Change Application for PDA Development Approval (DEV-2026-STH-4196)
Section 99 of the *Economic Development Act 2012*
62-74, 76-94, 96-108, 110-118, 120-122, 124-138 Springacre Road, Thornlands QLD 1464
Lots 13, 14 and 16 on RP53653; Lots 1 and 2 on RP128089 and Lot 2 on SP355573

In short, the purpose of this amendment application is to refine the approved detention basin lot boundaries within the riparian corridor area, pursuant to the outcomes of site-based stormwater management reporting provided alongside this application. This amendment application also seeks to satisfy Conditions 22(a) and 25 of the approval and includes the following attachments:

Figure 2: Revised detention basin arrangement

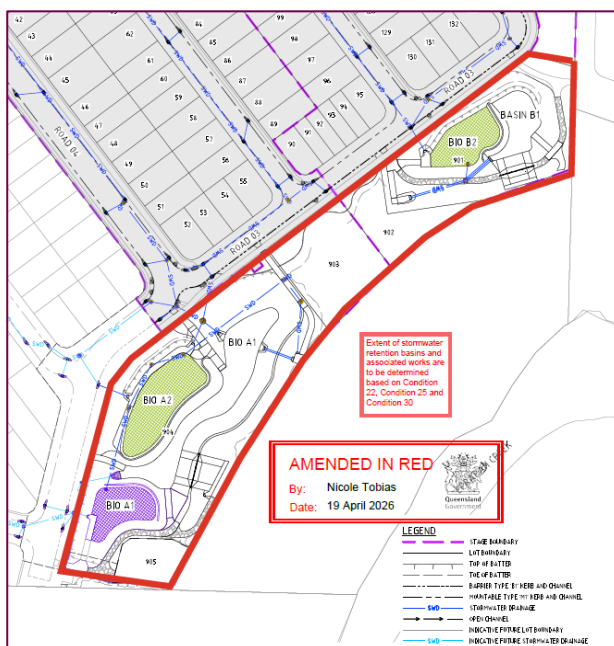
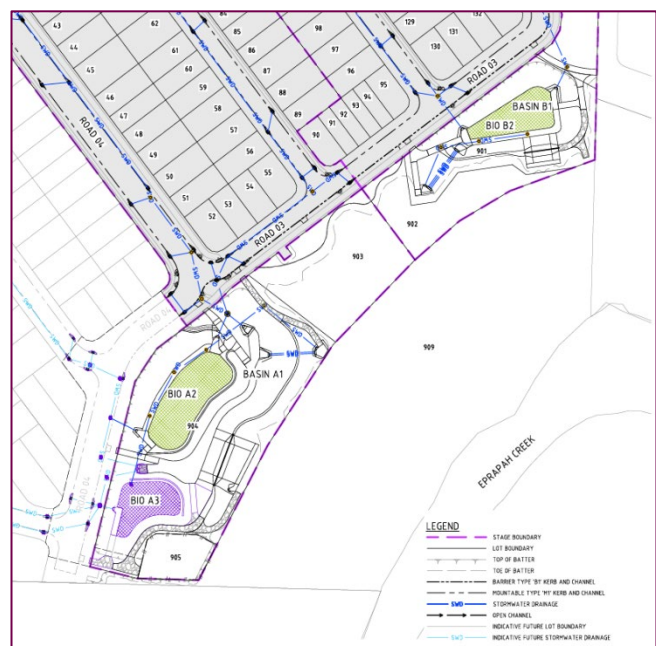
The SBSMP prepared by Engeny is in accordance with the requirements of PDA Guideline No. 13 and comprises a “no detention” strategy for stormwater discharge into Eprapah Creek, utilising a series of bio-retention basins which are typically smaller than the previously anticipated stormwater infrastructure. As such, opportunity exists for the reduction of the detention basin lot sizes, allowing for increased land for open space purposes within the riparian corridor area.

The below figures include a side-by-side depiction of the approved and revised bio-retention basin arrangements. A full copy of the Revised Civil Drawings is included as **Attachment E**.

Figure 4: Revised Plan of Subdivision

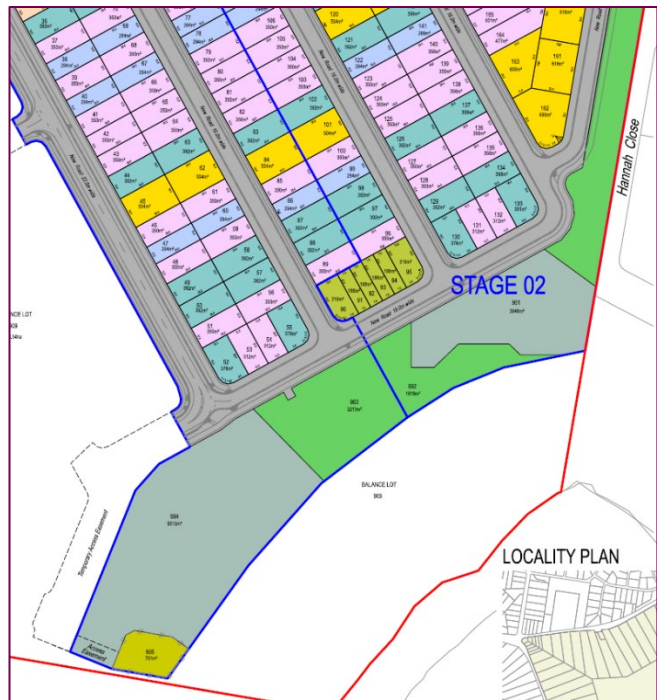
In order to satisfy the requirements of Condition 25 of the approval, an updated Plan of Subdivision is provided at **Attachment C** depicting reduced footprints for the detention basin lots (Lots 901 & 904) and increased footprints for the open space lots (Lots 902 & 903). It is noted that no changes are proposed to the sewerage pump station lot, which will remain accessed by an easement burdening Lot 904.

The below figures include a side-by-side depiction of the approved and revised Plans of Subdivision.

Figure 6: Proposed Erapah Creek Buffer Landscaping

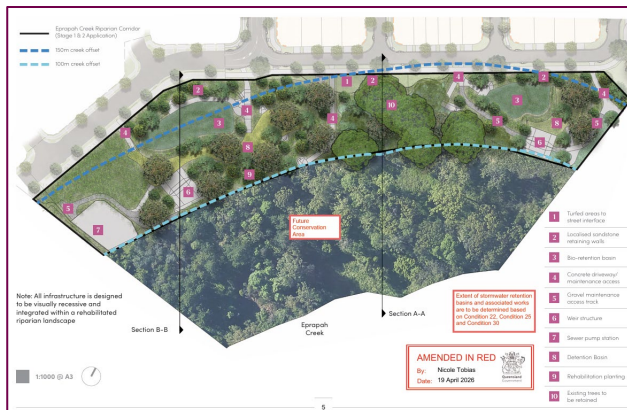
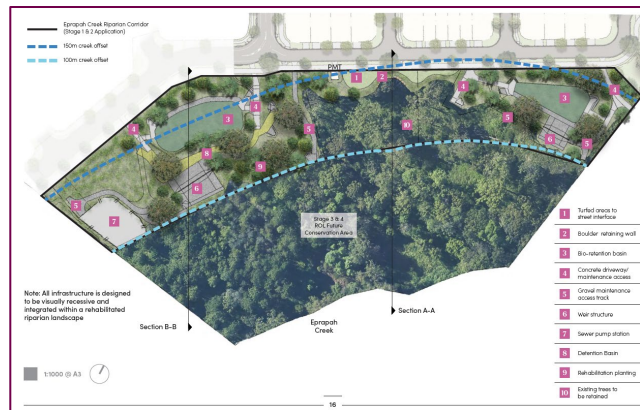
In terms of changes to landscaping within the riparian buffer area, the revised landscape plan includes:

- Slightly smaller footprints for bio-retention basins and more efficient use of space for detention lots in accordance with refined stormwater management reporting;
- Additional open space for tree retention and restoration purposes between the detention lots;
- A smaller detention basins on Lot 904 and Lot 901; and
- Rearranged open space areas along the road frontage to site a PMT.

The below figures include a side-by-side depiction of the approved and revised Landscape Plans for the riparian buffer area. Refer to **Attachment D** for a full copy of the revised Landscape Concept Plan.

Figure 8: Revised Centre Connector Cross-section

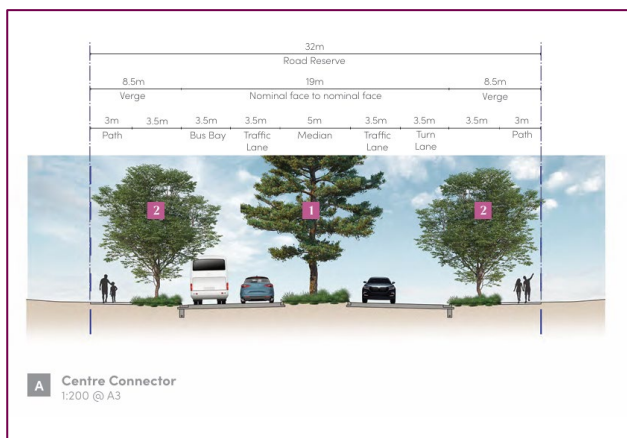
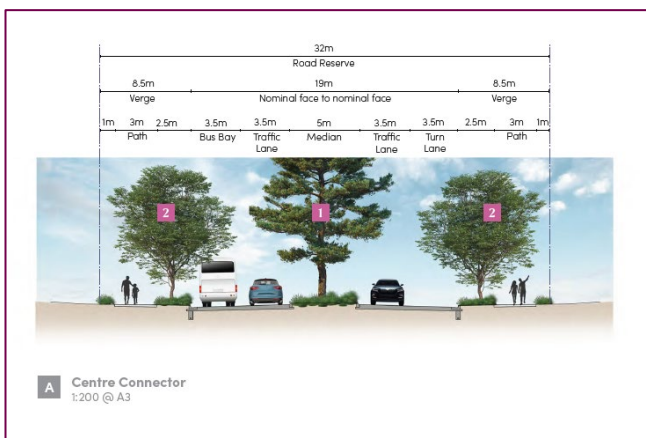
In addition to the above changes, this amendment application also seeks to alter the verges of the Centre Connector street to incorporate landscaping on both sides of the footpath, for both sides of the road. The proposed change maintains 3m footpath pavement widths, though relocates a 1m width of landscaping from the roadside to sit between the footpath and adjoining properties.

This proposed change results in a contiguous 1m landscaping strip extending from the site entry through to the roundabout and is considered to be an improved landscaping outcome for the site's entrance, as it will soften the transition to built form associated with the future mixed-use buildings that will eventually adjoin the street.

The below figures include a side-by-side depiction of the approved and revised cross sections for the Centre Connector street. Refer to **Attachment D** for a full copy of the revised Landscape Concept Plan.

Figure 9: Approved Earthworks Plans

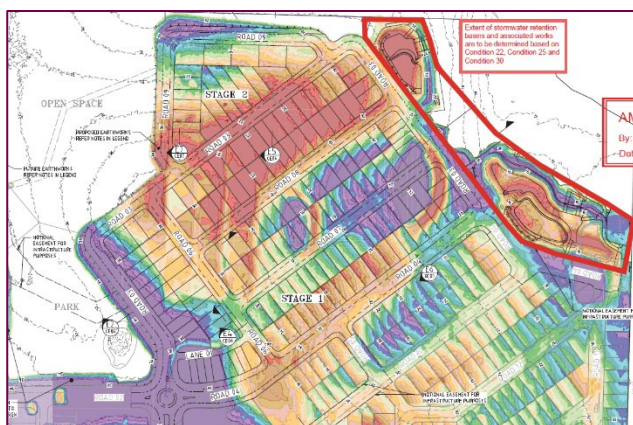
The Revised Civil Drawings including bulk earthworks are included as Attachment E, these include an update to the approved Bulk Earthworks plans and detailed design information regarding engineering design. In particular there have been design amendments to reflect the new design for the basins in the open space, and the interface along the northern boundary of Stages 1 and 2 with future open space. The proposed earthworks in this location have been amended in consideration of the requirements within the approval conditions for compliance with Redland City Council preferences related to use and design of retaining walls within parks.
